Location:	4265 Foothill Boulevard. (APN: 035 -2352-008-01). (See map on reverse)
Proposal:	Remodel of a “Chevron” gas station, including the creation of a convenience market, addition of an automated car wash, and site improvements.
Applicant:	Navdeep S. Grewal / NG Grewal One
Owner:	NG Grewal One
Planning Permits Required:	Major Conditional Use Permit (CUP) to establish a Convenience Market Commercial Activity and to add a Drive-Through Nonresidential Facility. Minor CUP to add an Automotive Repair and Cleaning Commercial Activity. Regular Design Review for the construction of convenience market, car wash, and site improvements.
General Plan:	Community Commercial
Zoning:	CC-2 Community Commercial 2 Zone
Environmental Determination:	Pending
Historic Status:	OCHS Rating: X
City Council District:	5
Date Filed:	Oct. 1, 2018
Action to be Taken:	Review proposed design. Provide design recommendations and refer to the Planning

SUMMARY

CITY OF OAKLAND PLANNING COMMISSION

Case File: PLN18376
Applicant: NG Grewal One
Address: 4265 Foothill Blvd
Zone: CC-2

1 SITE PLAN
 SCALE: 1" = 10'-0"

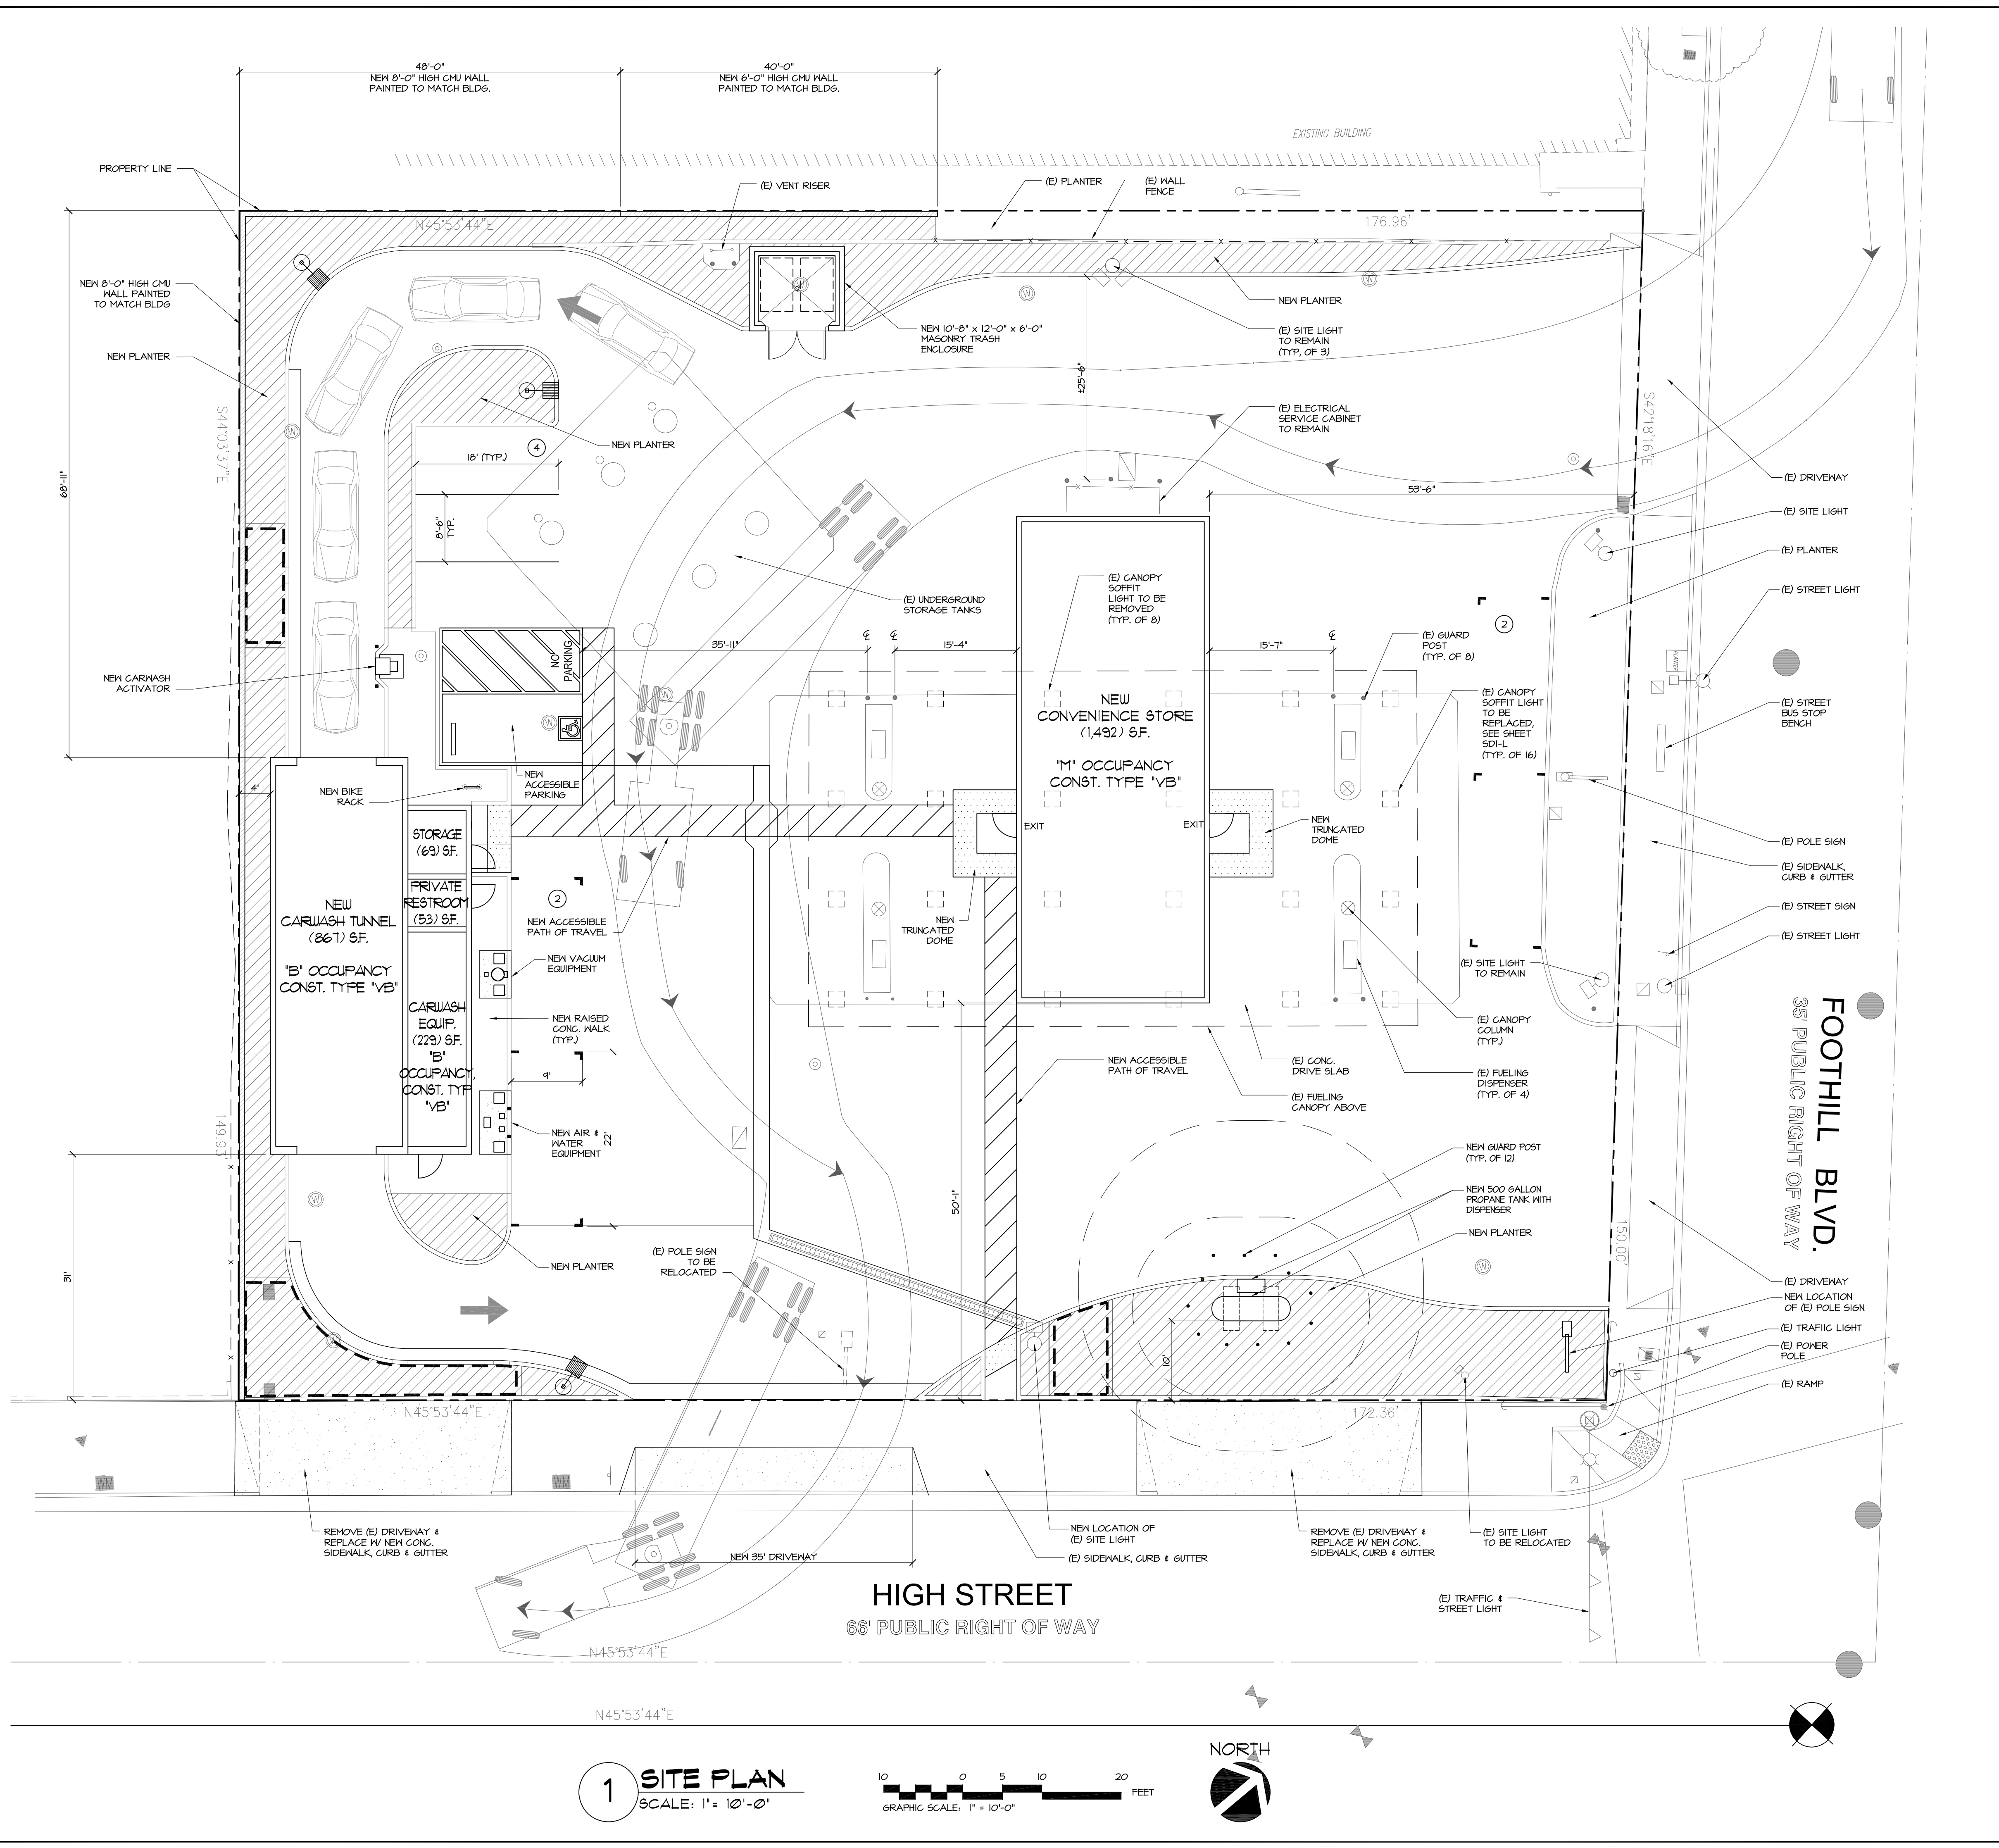
The proposed project would consolidate two curb cuts on High Street into one curb cut and preserve the two on Foothill Boulevard, leaving three curb driveways into the gas station, despite recommendations to remove one curb cut from Foothill Boulevard and create a one-way in and out circulation system. This issue is further discussed in the "Key Design Issues" Section of this report.

- DOT recommends that the driveway on Foothill, adjacent to the intersection, be eliminated to remove unnecessary conflict points and to improve safety adjacent to the intersection and to increase safety near the existing bus stop on Foothill.
- Two-way curb cuts should be 20 feet wide typical, and 24 feet wide where driveways are anticipated to have high volumes. Due to the land use, we recommend reducing the width of the driveways to 24.’
- This project is at the nexus of two major corridors. To provide more certainty and smoother transitions for drivers, people on bikes, and pedestrians, we recommend considering a one-way in (off of Foothill) and one-way out (off of High) and if this recommendation were considered, then we’d also recommend narrowing the driveways to 12 feet.

Staff requests the DRC to comment on the proposed site and circulation plan, particularly the proposed curb cuts.
